TECHNICAL SERVICE BULLETIN, VIN: WSB-13 Updates for 12-Volt Charging System, Open Trail Motorhomes

Technical Service Bulletin WSB-13 Repair Instructions

Purpose: Update the electrical system for Open Trail Motorhomes with a 12-volt operating system.

Models: 2025 & 2026 Open Trail Motorhomes

Figure 1A

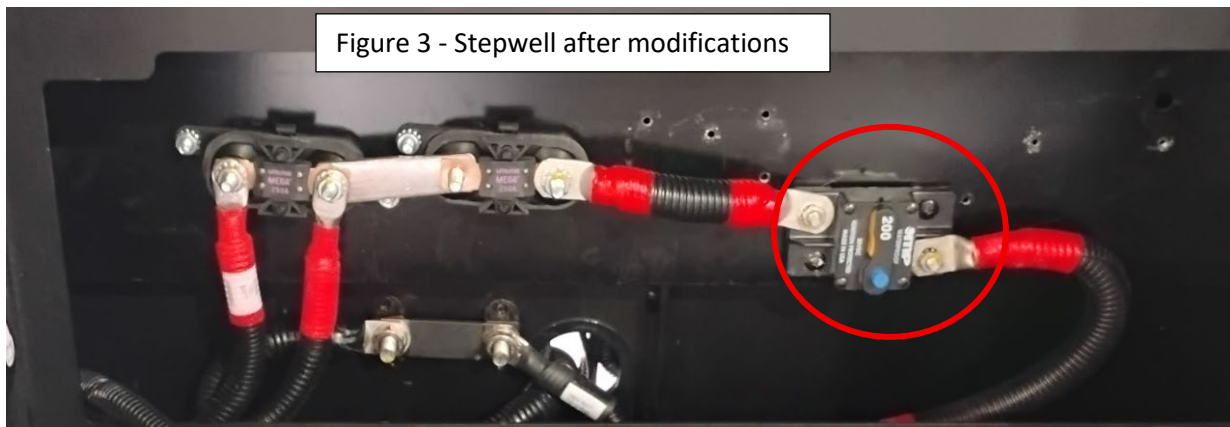
1. Turn off all power to coach.
 - Disconnect the shore power cord from coach.
 - Turn off the battery disconnect switch found in the step well.
 - Disconnect chassis battery at the battery disconnect by removing the access panel next to the accelerator pedal. Push in red or black tab and disconnect. NOTE: Wait 20 minutes after turning engine off to avoid any unintentional short circuit or engine warning lights. See Figure 1A and 1B.

Figure 4 - Electrical box before modifications- inverter model may vary.

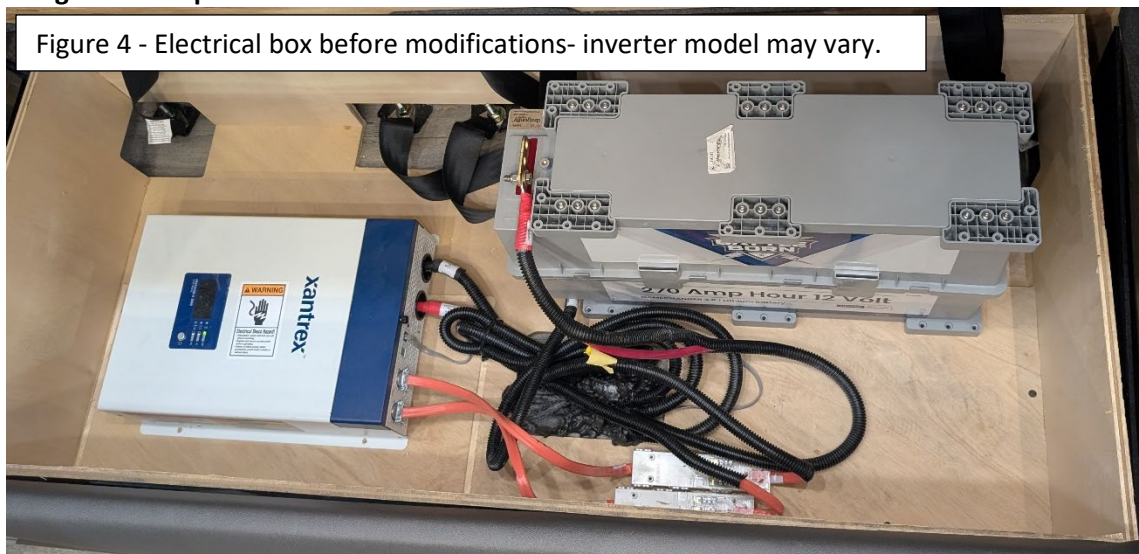
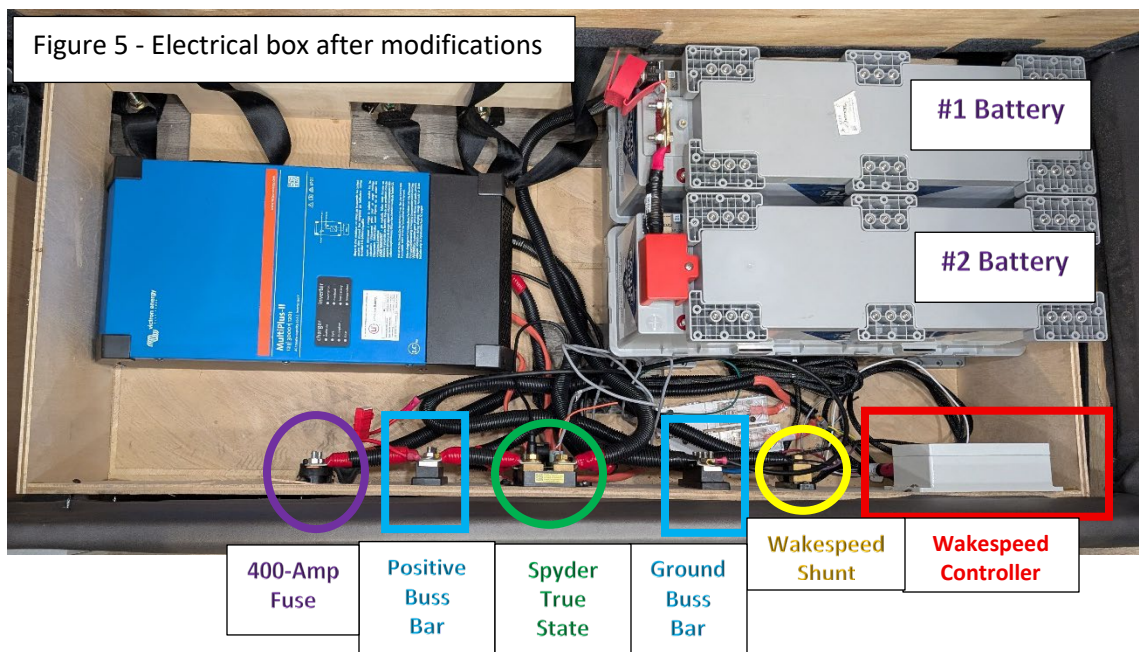
8. Inverter (Model in electrical box may vary, see figure 4)
 - Disconnect the Molex connectors.
 - Remove cover and disconnect cables.
 - Remove screws securing inverter to floor of electrical box and remove inverter.

13. 400-amp fuses, see figure 5 purple circle
 - Install one (1) fuse holder part 5001843 and fuse part number 5049265, see figure 5, purple circle.
 - Install one (1) fuse holder part 5001843 and fuse part number 5049265 **below** the Spyder True State, see figure 5 green circle.
14. 4 lug buss bars, part 5176552, see figure 5, blue rectangles.
 - Install ground buss bar between green and yellow circles.
 - Install positive buss bar between purple and green circles.
15. Wakespeed Controller, part number 5149451, to battery box wall, see figure 5, red rectangle.
16. Battleborn battery, part number 5157166, in electrical box, see figure 5 for reference.
 - NOTE: Leaving batteries in an upright position initially will make it easier to tie in wire connections.
17. Battery jumper cable kit part # 5160217 to batteries.
 - Positive connection on the top of the batteries.

- Ground connection on the bottom of the batteries.
 - 600-amp fuse holder, part 5079799 and 600-amp fuse, part 5068275 to positive side of #1 battery.
18. Wakespeed shunt, part 5160785, to battery compartment as shown figure 4, yellow circle.

19. Spyder True State (from stepwell), figure 5, green circle
 - Matching the orientation shown in figure 6.
 - Install part 5195335, from True State to positive buss bar.

- Install the battery sense wire (from step 5), from True State to the #2 battery ground terminal.
 20. Install harness 5195719 (400A to alternator)
 - To the 400-amp fuse (shown purple circle figure 5)

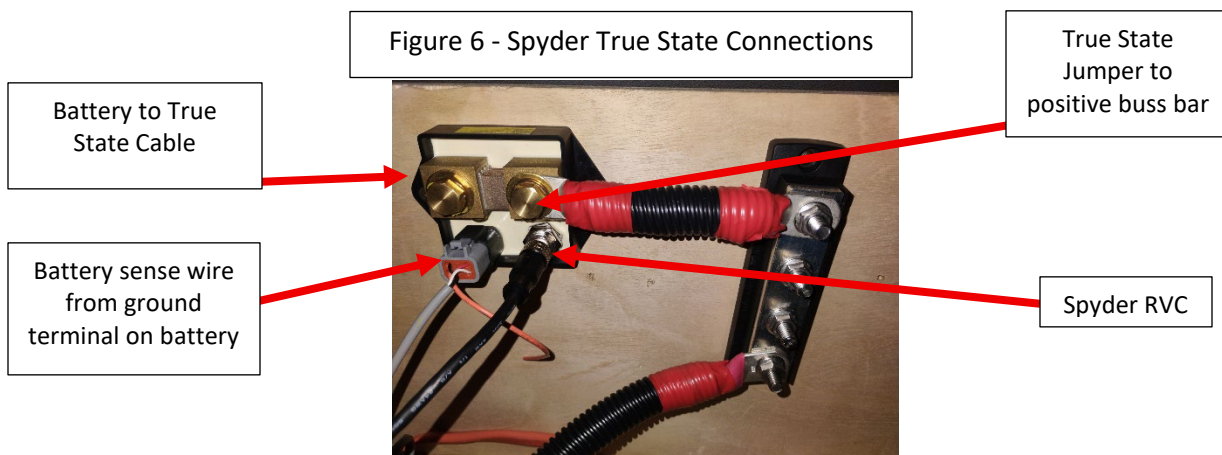
*****For reference only, the correct set up for the True State connections are shown in figure 5. Do not connect the Spyder True State to battery until all work has been completed!!****

Figure 7 - Inverter Connections

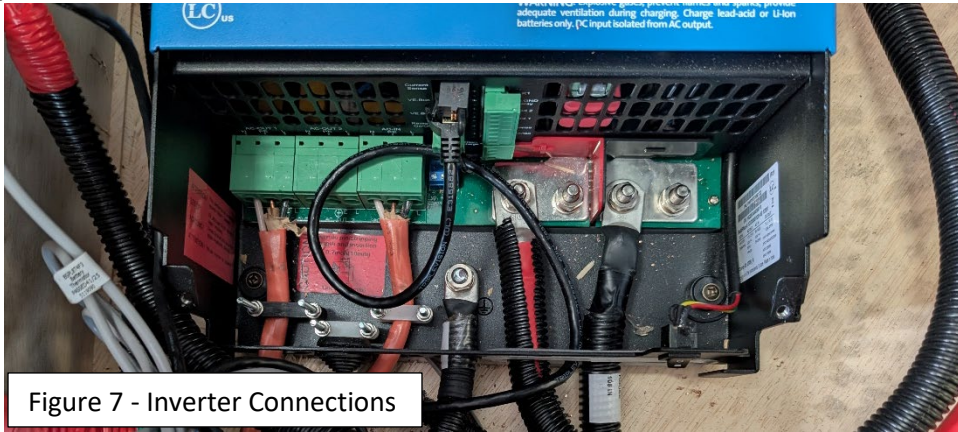
- Route cables through rubber grommets to clamps, securely but do not overtighten.
29. Secure the base of the inverter to the battery box, see figure 7.

Figure 8

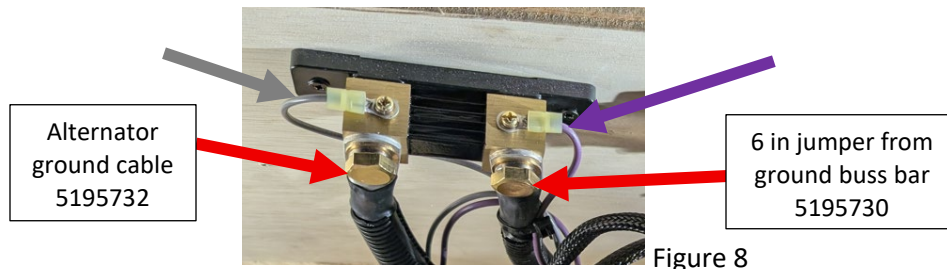
- Verify engine wire is routed through the MB installed grommet to chassis battery.
 - Connect the purple and grey wire to the shunt with ring connector as shown in figure 8.

Figure 9

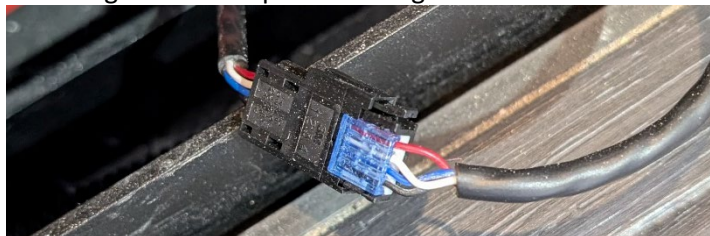
38. Connect Spyder RVC to the Spyder TruState, see figure 6.
 - Route from the electrical box to the step well and secure as needed.
 - Trim excess wire and install new Spyder connector part 5066157 to RVC, wire sequence red, white, blue, and black starting from the clip side see figure 9.
 - Install new Spyder connector part 5066158 to existing Spyder cable in the step well, Red, white, blue, black starting from the clip side. See figure 9.

Figure 10

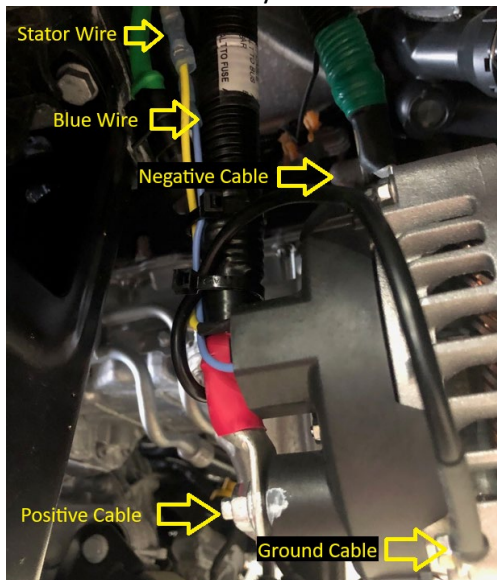
52. Install secondary alternator, part # 5176949. Torque bolts to 37 ft/lbs. See figure 10 and 11.

- Connect positive cable, 5195719 and torque to 18 ft-lbs.
- Connect ground cable, 5195732 and torque to 18 ft-lbs.
- Locate blue and yellow (stator) wire connection in the Wakespeed harness and connect to alternator blue and yellow wire connection, making sure to match colors when connecting.

Figure 11

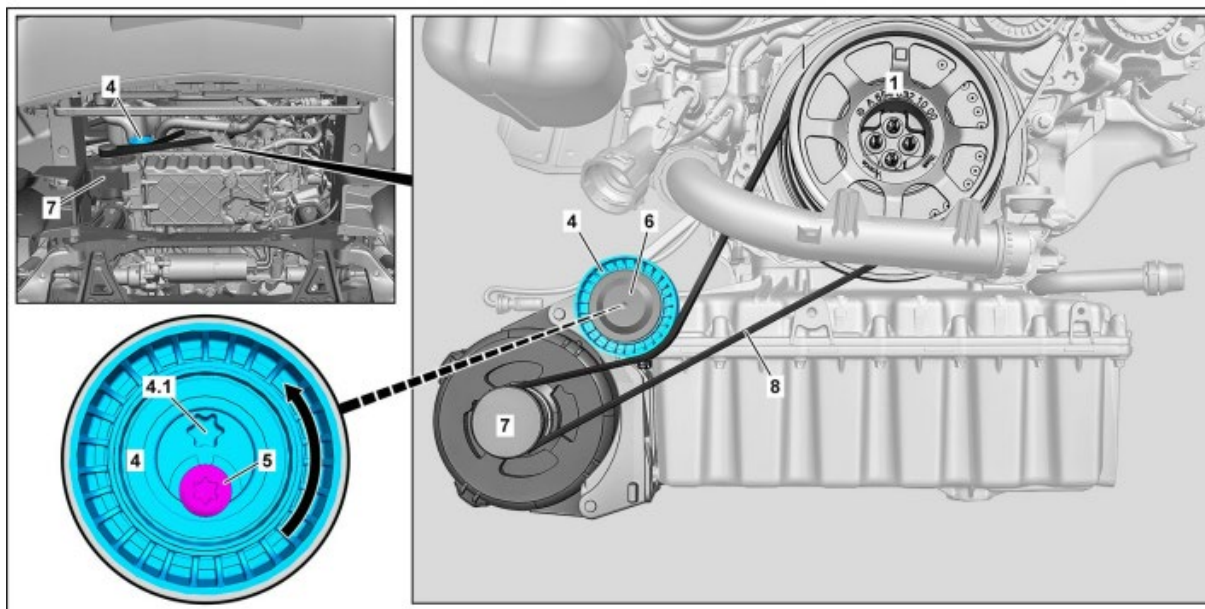
49. Install bracket, 5195469 using screws, 5195470, as shown in figure 11 and torque bolts to 15 ft lbs.
50. Install belt pulley, 5197011, as shown in figure 11, #1.
 - Remove existing pulley and keep mounting bolts to reinstall new belt pulley.

- Install new pulley and tighten mounting bolts to 36.9 ft lbs (50 Nm).
- Secure bolts by a quarter turn working in a star pattern, repeat x3.

51. Install the tensioner pulley, 5195418, as shown in figure 11, #4, but do not tighten.

53. Install alternator belt 5152905, reference figure 11.
 - Loosen bolt (5/T45) if screw is tightened.
 - Install poly-V-belt by Positioning the poly-V-belt (8), as shown, on the belt pulley (1), the tensioner pulley (4), and belt pulley of the alternator (7). The belt pulley (1), tensioner pulley (4), and belt pulley of the alternator (7) must be clean and free of grease. This prevents damage and malfunctions. Do not use belt wax or similar products. This avoids malfunctions.

- Tighten screw (5) to specified torque (initial torque). Ensure correct installation position of poly-V-belt (8). Otherwise, belt drive can be damaged.

54. Swivel tensioner pulley (4) on the cutout (4.1) clockwise (in the opposite direction of the arrow) until the T55 socket is aligned to the **2 o'clock position** and hold. **Do not** tension poly-V-belt (8) too tightly or too loosely. Otherwise, belt drive can be damaged.

55. Tighten screw (5) to 22 ft lbs.

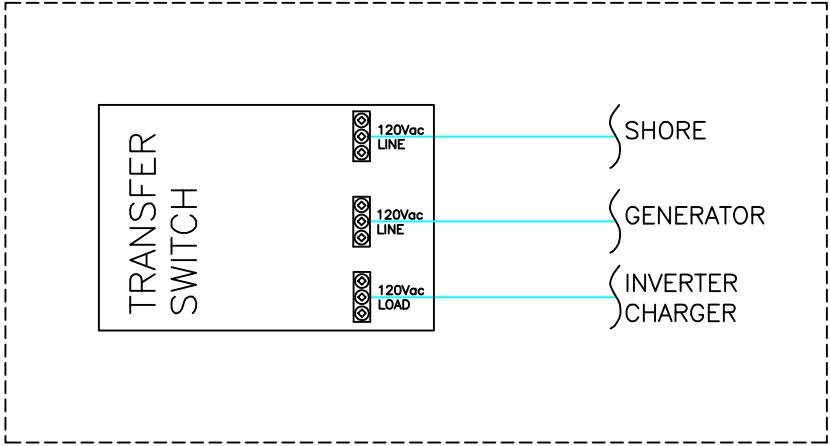
56. Remove cover of A/C unit to verify if a soft start is installed or not.
57. If soft start is needed, install part # 5174989, following the instructions included in the box.
